CHANGE ORDER #1 - SCHEDULE OF VALUES - ALFRED RING PARK

PROJECT NAME	City of Gainesville Boardwalk Replacement at Alfred Ring Park			APPLICATION NO.		APPLICATION DATE	12/06/24
PROJECT MANAGER	Peter McNiece/Maria Montauderes	PROJECT NO.	WSPP-240046-WB	% COMPLETE TO DATE	0%	PERIOD TO

DRAWING TITLE:
OVERALL SITE PLAN AND ENLARGED BOARDWALK PLANS

BRIDGE NORTH TRAILHEAD BRIDGE
 1/16" = 1'-0"

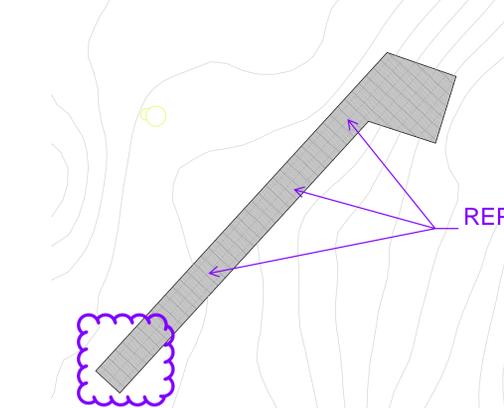
REPAIR six (6) 2"x 12" joists

4 BOARDWALK - 3
 1/16" = 1'-0"

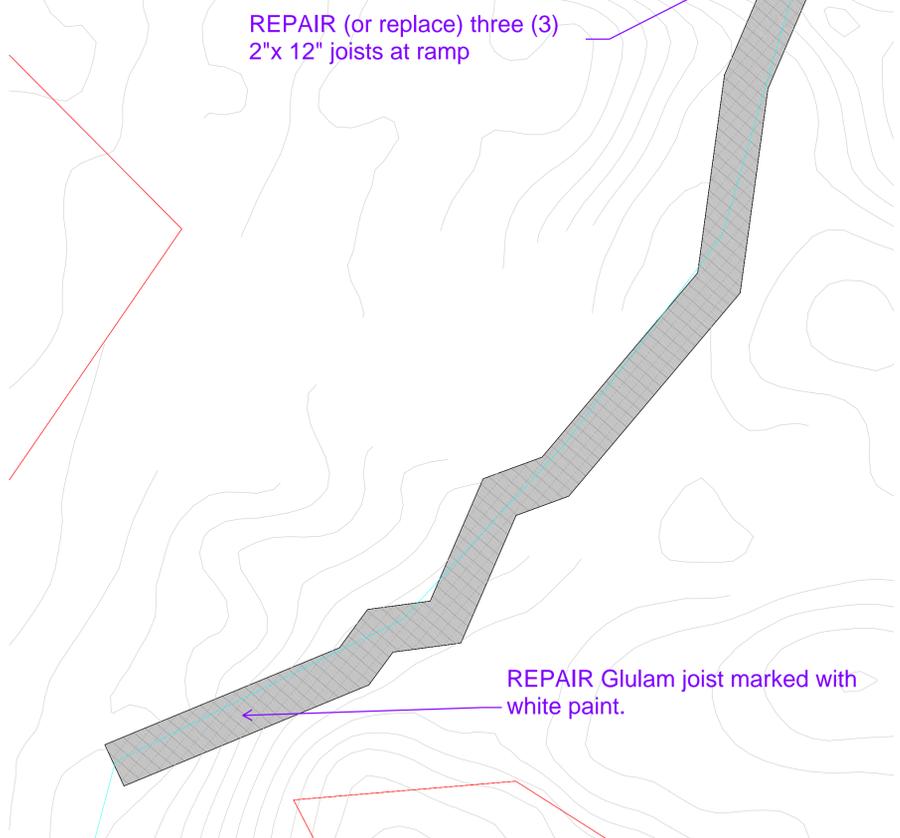
Replace the existing lumber at ramps with 2"x 6" WearDeck structural composite. Add blocking as necessary to maintain desired top of board elevation.

1 OVERALL SITE PLAN
 1" = 160'-0"

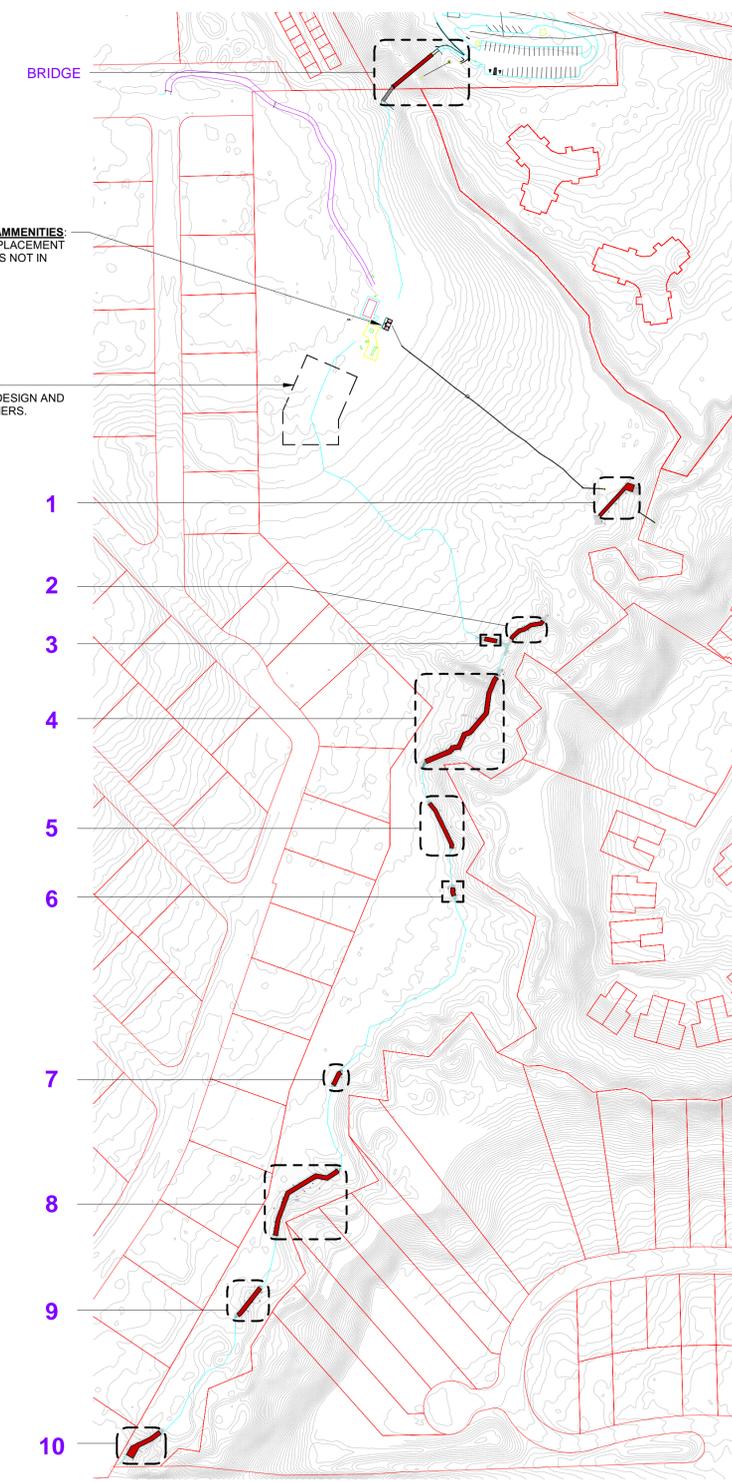
Replace all deteriorated 2"x 12" joists with 0.8 CCA 2"x 12" lumber.

Replace all joists at approach ramps with deteriorated joists from the abutment to the start of the elevated boardwalk with 2"x 6" WearDeck structural composite.

At boardwalks without railings with deteriorated 2"x 12" joists, the intent is to replace those with 2"x 6" WearDeck structural composite. Note this may create the need for blocking along the beams to maintain the proper elevation of the deck boards.

There are approximately forty (40) 6"x 6" blocking members that appear to have more than just minor water damage to the cut tops. Those should be replaced with 0.8 CCA lumber.

For posts that have only minor damage, apply sealer (provided by the City of Gainesville).

Maintain the structural design of the existing boardwalks to the greatest extent possible.

10 BOARDWALK - 7 - SOUTH TRAILHEAD
 1/16" = 1'-0"
BOARDWALK SUMMARY:
 APPROXIMATE AREA OF BOARDWALK DECK = 769 SF
 APPROXIMATE LENGTH OF RAILING = 167 LF

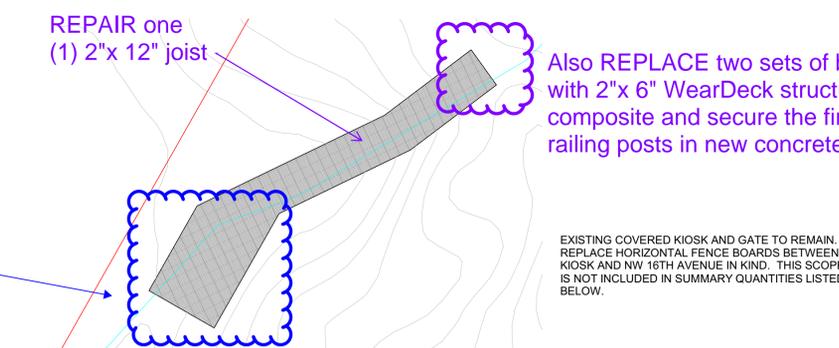
Replace ALL joists with comparably sized 0.8 CCA lumber. All beams and guardrail posts to remain.
